U. S. NUCLEAR REGULATORY COMMISSION

Report No. 50-373/374/OL-85-~~01~~⁰²

Facility Name: LaSalle County Nuclear Station

FACILITY COMMENTS

1.5 Using the following figures, choose the correct answer for each of the three (3) questions asked below:

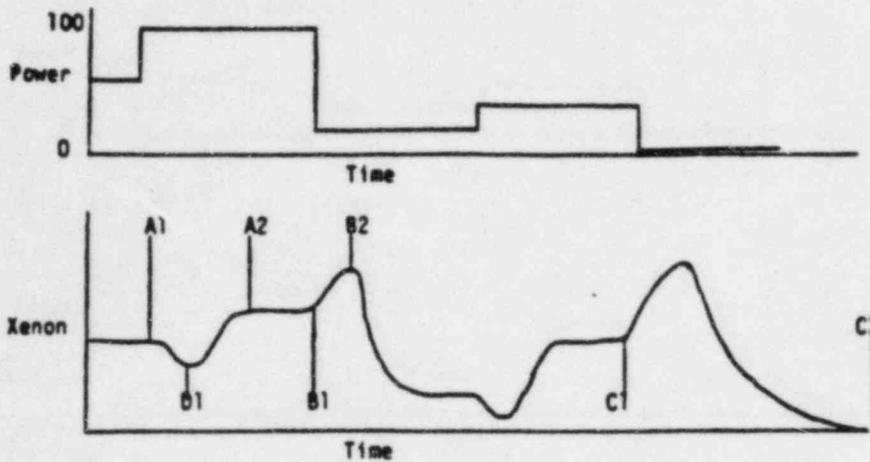
- 1.5b A nonLaSalle reference was used in the answer key. According to the LaSalle Reactor Physics review lesson plan submitted with the exam reference material, Xenon peak on a down power transient would occur 4-6 hours after the power change. The answer key lists #2 as the correct answer (2-6 hours). However, answer #3 (5-7 hours) fits this time frame as well as #2 did and should be counted as a correct alternate answer.

- 1.4b Comment accepted. Credit was given for either 2 or 3.
- 1.5b Comment accepted. This question is from the examination question bank. NUREG-1021 does not prohibit the use of non-plant specific references in Section 1 and 5 of the examination. The answer key will be changed to eliminate any confusion.
